Adequacy Review Report Information Request No. 2

Project Assessment 2014-0002

Casino Mining Corporation Casino Mine

May 15, 2015

Figure 1: Figure 1: 24 hour PMP contour lines for Alaska (taken from Figure 2-12 of TP-47, Weather Bureau, 1963)

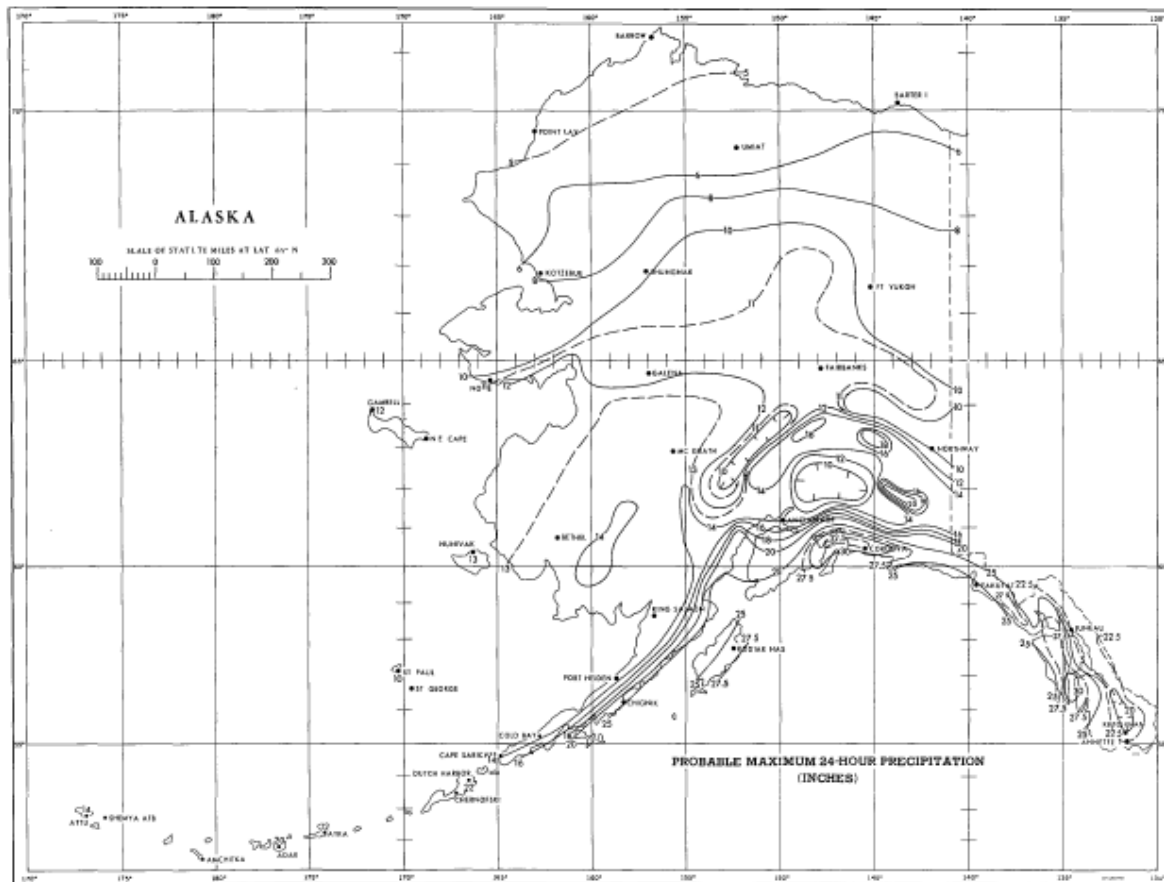
In response to R33, CMC provides additional details on the methodology used to estimate Probable Maximum Precipitation (PMP). EcoMetrix (YOR 2014-0002-399-1) indicates the methodology used by the Proponent to estimate PMP is sensitive to the value used for standard deviation of the annual extremes of rainfall and that the Proponent should use all years of available rainfall data and not just the dataset used to develop the frequency maps in the 1985 *Rainfall Frequency Atlas for Canada*. EcoMetrix indicates the appropriate value of PMP may be greater than estimated.

The Executive Committee utilized other sources of information to estimate PMP for the Casino Project. Contours presented in Figure 2-12 of Technical Paper No. 47 (TP-47) (Weather Bureau, 1963) indicate that a 24-hour PMP of 10 inches (250 mm) is expected for Eastern Alaska at the same latitude as the project site. The 1963 Alaska PMP analysis completed for TP-47 utilized 184 Alaska and 33 Canadian meteorological station records. Figure 1 presents the 24-hour PMP contours from TP-47. CMC's proposal indicated a 24-hour PMP value for mine facility design of 159 mm as presented in Table A.4.9-2 of CMC (March, 2015).

The Executive Committee requires more information on PMP. Therefore, please provide the following information:
